Solicitation Addendum

Addendum No.:	1
Solicitation No.:	20-R074101SAM
Solicitation Title:	Coquina Beach Landscaping Phase 1
Addendum Date:	April 17, 2020
Procurement Contact:	Sherri Meier

COQUINA BEACH IPO

I-100

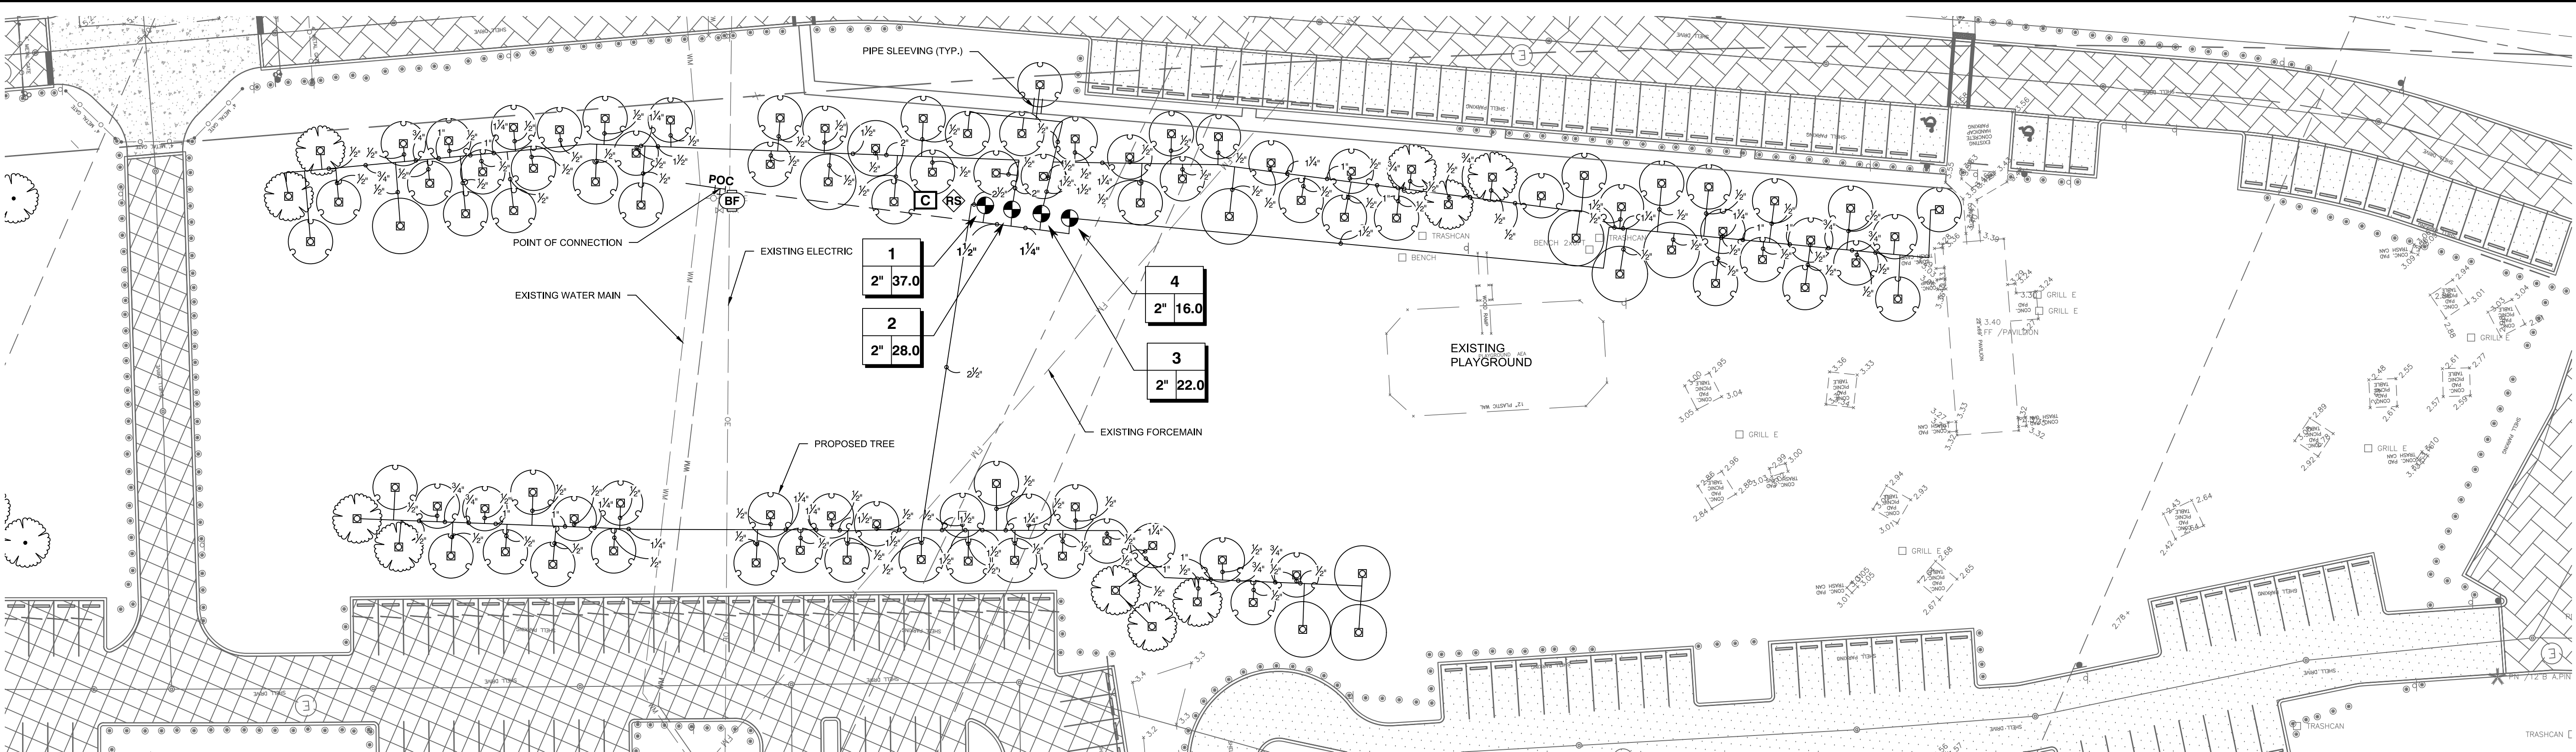
- a. **“The valves specified are DC and the controller specified is AC. One or the other is wrong as they will not function together.”**
- b. **“Also, the controller specified is an 18 Station controller. We are installing only 4 zones (stations). Are the extra 12 stations for future expansion or is that a mistake also?”**

- a. Removed notation for “DC” and changed specification on schedule.
- b. This was not a mistake on the plans. The ACC was specified for its durability and ability for future expansion. We dropped it to the I-Core which will be installed with 6 stations instead of the minimum 12 of the ACC. This model still provides ability for future expansion if more zones are added.
